Technical Memorandum

From: Sabine and Neches Rivers and Sabine Lake Bay Basin and Bay Expert Science Team (BBEST) BBASC Flow Regime Review Subcommittee (BBEST Subcommittee)
Jack Tatum, Co-Chair, SRATX; Scott Hall, Co- Chair, LNVA

Subject: Evaluation of TCEQ proposed and Sabine-Neches BBASC proposed environmental flow standards and set-asides for the Sabine and Neches River Basins

Figure 1

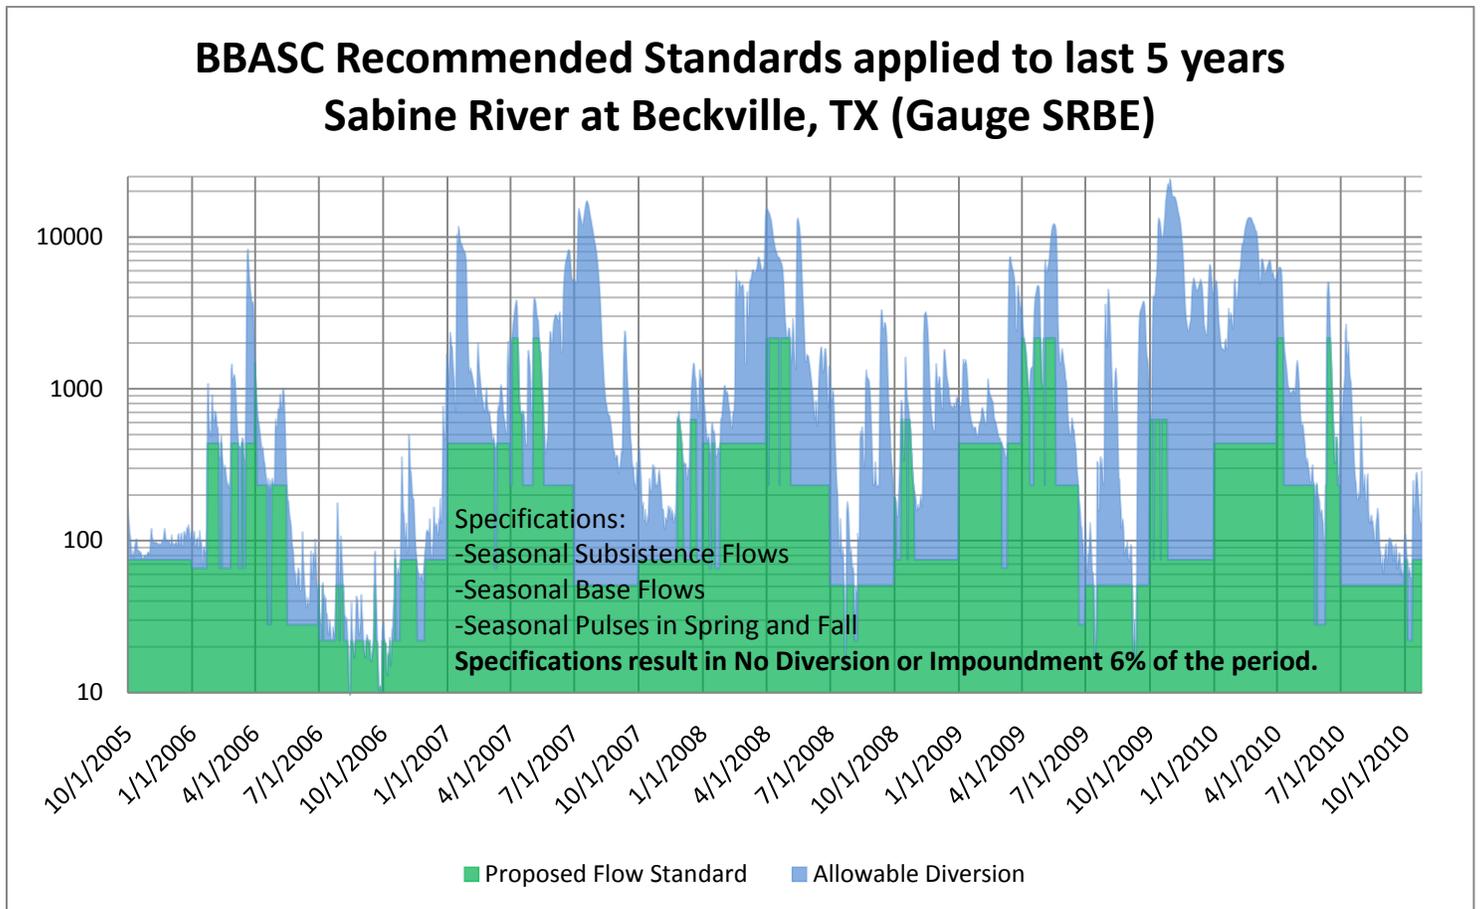
One simplified approach to visually demonstrate and compare the potential impacts of the proposed TCEQ standards with the BBASC standards is provided in Figures 1 and 2, below. Historical flow hydrographs for the last five years are shown for two locations within the Sabine and Neches River basins, the Beckville and Rockland gages, with the required respective pass-through flows at each location also shown in the graphs for the two proposed standards. These graphs illustrate the amount of flow above the respective environmental flow standards which would be available for diversion or storage during this 5-year period for a potential new project in each area and the resulting reductions in total volume of diversion for those flows is noted within each graph.
